CHANGE }

No. 1 }

**Organizational Maintenance Manual
CRANE-SHOVEL, TRUCK MOUNTED; 3/4 CUBIC YARD;
20 TON; WITH CLAMSHELL, DRAGLINE, AND BACKHOE
ATTACHMENTS; G.E.D. (HARNISCHFEGER CORP MODEL M320T2)
NSN 3810-00-151-4431**

TM 5-3810-294-20, 5 April 1974, is changed as follows:

Figure 2-105.1. Adjusting front and rear drum brakes.

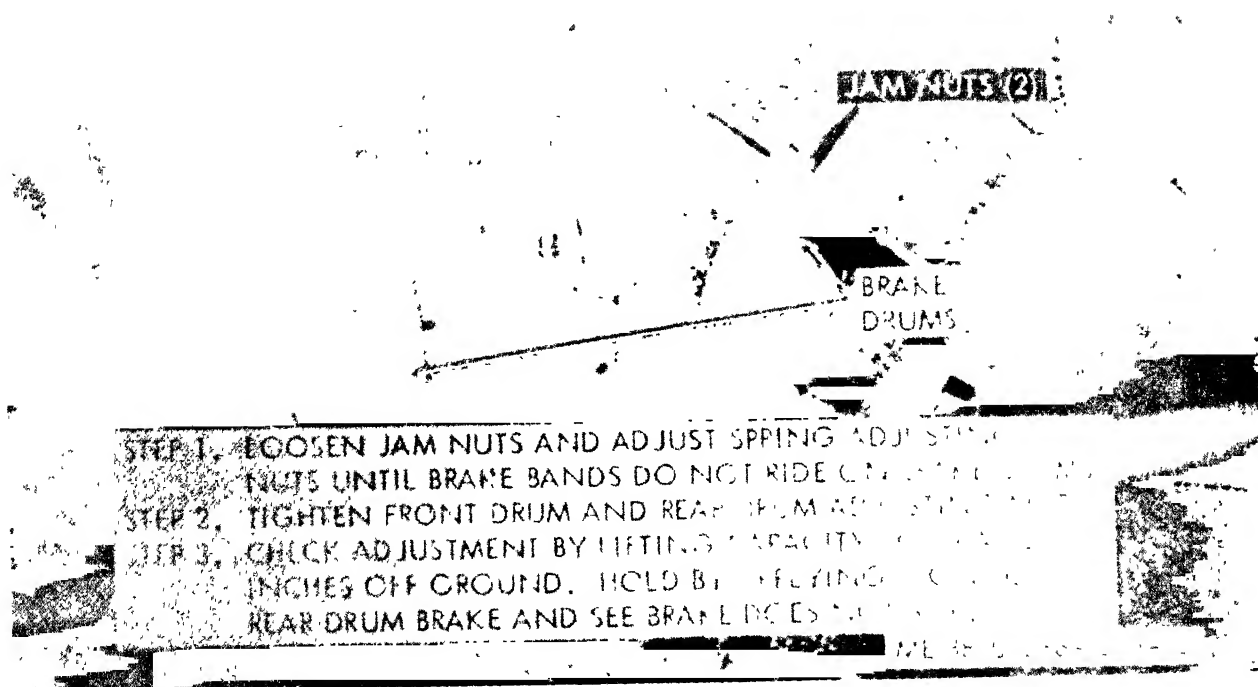
Figures 2-105.1 and 2-105.2 are added as follows.
